Rhine Dress Ltd. (11505)

Talla Road, Fatullah, Narayanganj.

02.July.2014

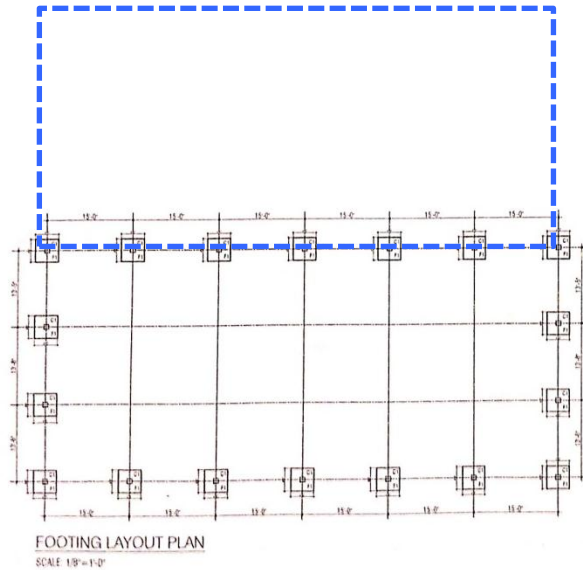
Concerns on the stability system for roof shed truss sitting on brick wall. The roof must be checked for stability and capacity especially the connections between steel structural elements and brick wall. Stability under wind uplift needs to be checked in particular.

The structural details of this shed shown on structural drawings do not match the actual as-built conditions.
